**PRODUCT DFM REPORT**  
(产品结构评审)

Project Name (项目名称):	Handle Tablet	Checked By (审核):	杨金坡
Project Manager (项目经理):	邱振彬	Date (日期):	2017-02-24
Mobile (电话):	--	Website (网址):	www.bestcreating.com
Email (邮箱):	--	Version (版本):	V0.1

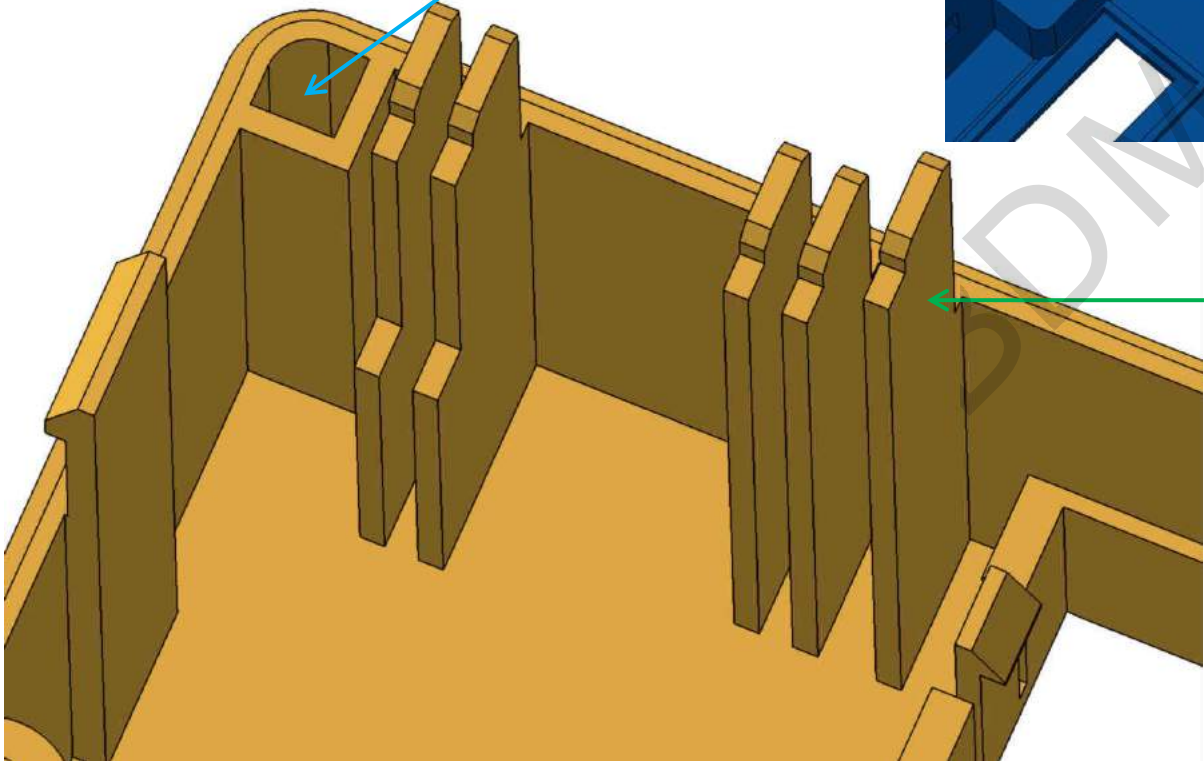
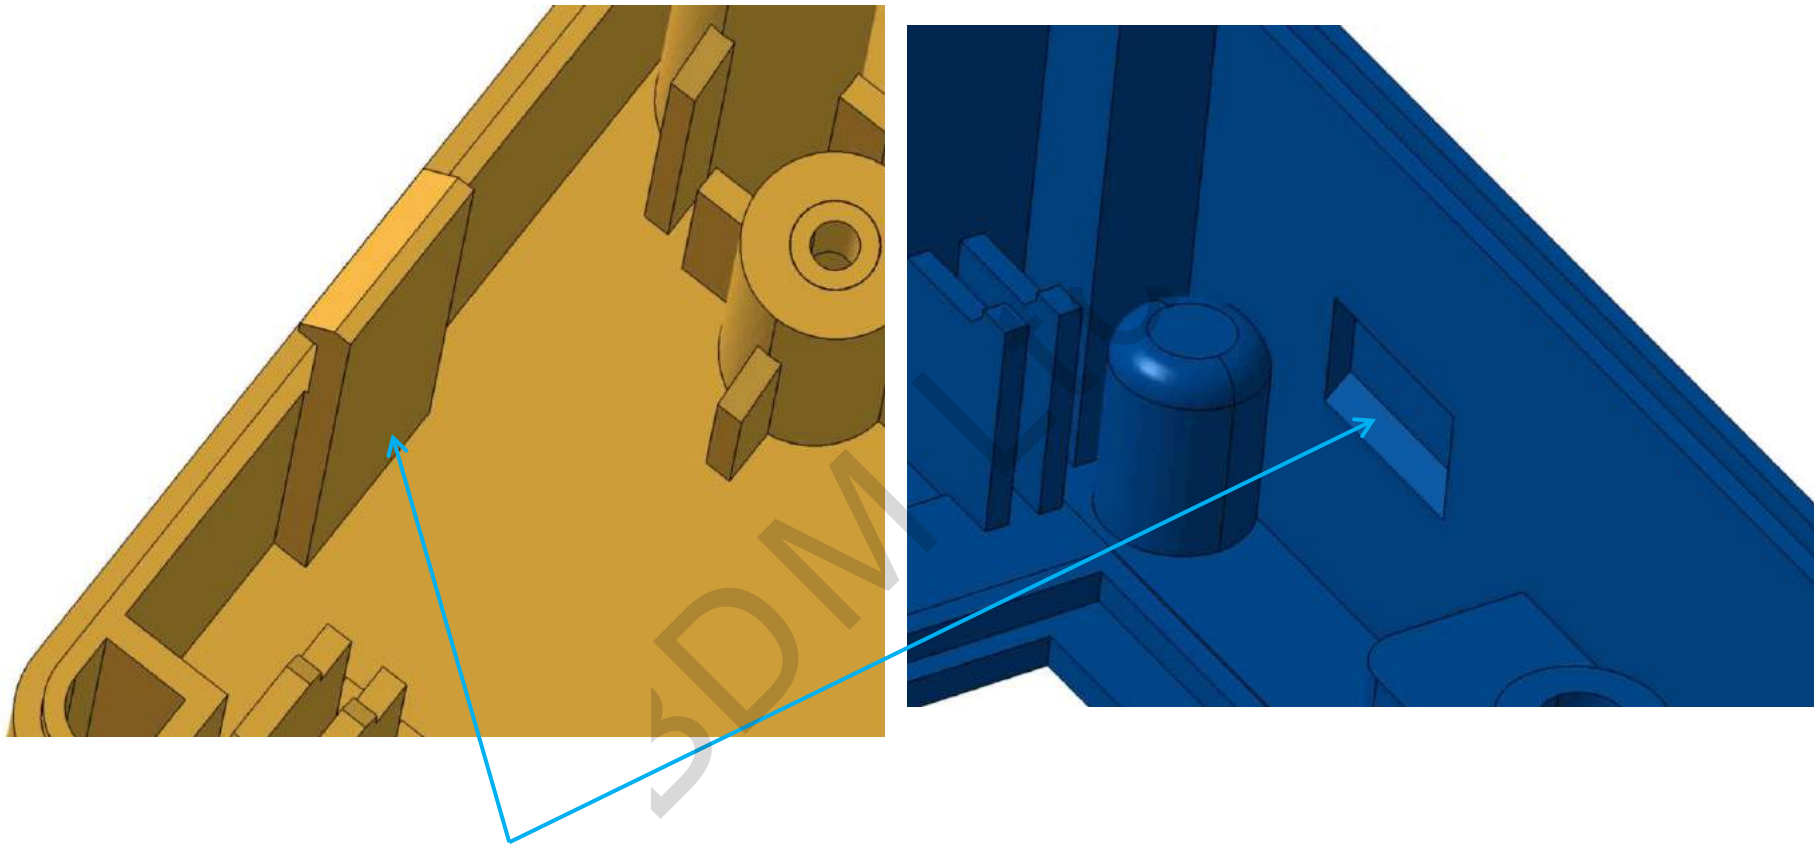
Please make the thickness of the ribs 1.2mm. Typically 1/3~1/2 of the nominal wall thickness is ok.

This kind of snaps or hook is not recommended.  
As the bottom area will be very thick, sink marks can't be avoided.  
And the shape is also not recommended.  
See the next page for the snaps we typically used.

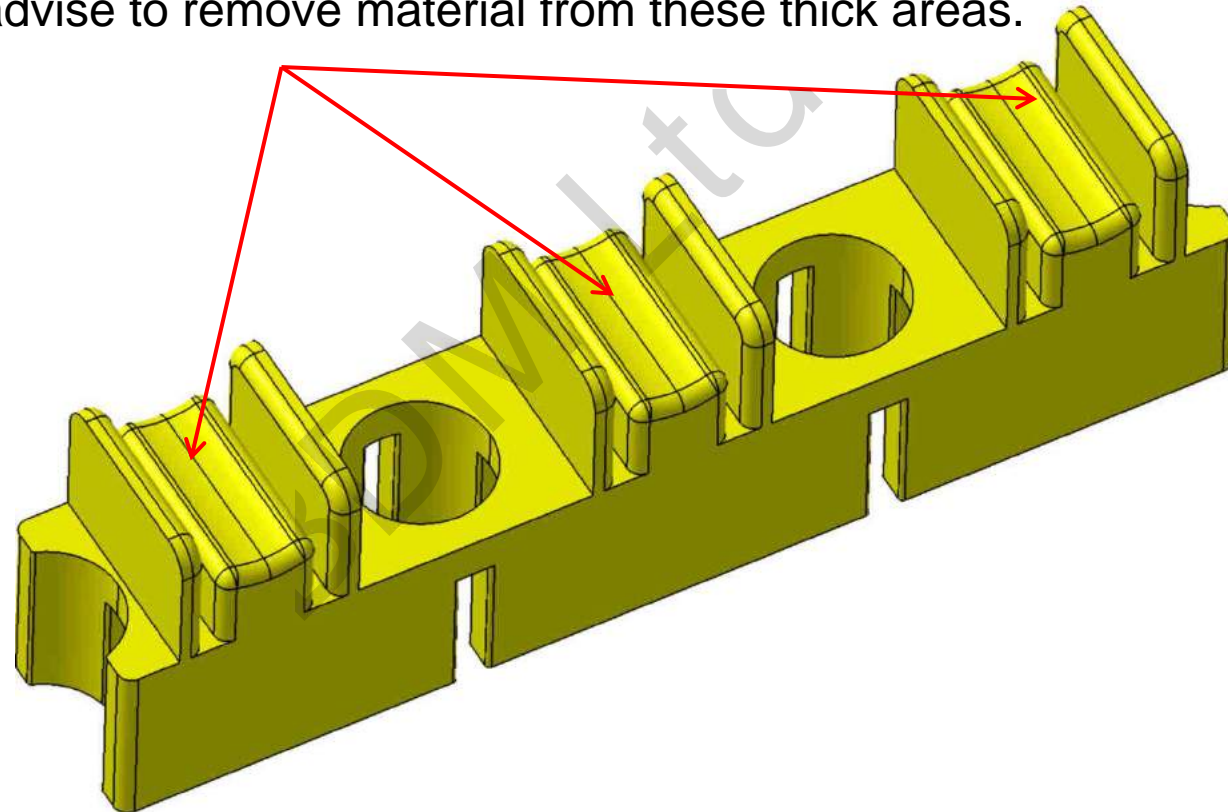
We advise to remove material from these thick areas.
